SILENCER CLAMP INSPECTION

AFFECTED MODELS:

2021 890 ADVENTURE

Fig.1 - Incorrectly mounted clamp

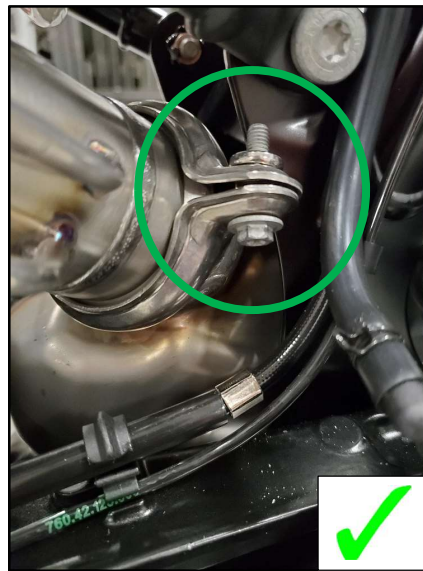
On affected VIN's if the silencer clamp is mounted incorrectly as shown in Fig.1 the clamp may come in contact with the protective sheathing on the rear brake line, the brake hose bracket or the swingarm during heavy compression of the suspension and with excessive payload.

Please check that the clamp is mounted correctly as shown in Fig.2 at the transition between the presilencer and silencer.

1. If the silencer clamp is positioned incorrectly loosen the screw, take clamp off and reposition the clamp to the position that is shown in Figure 2 and reinstall the screw.
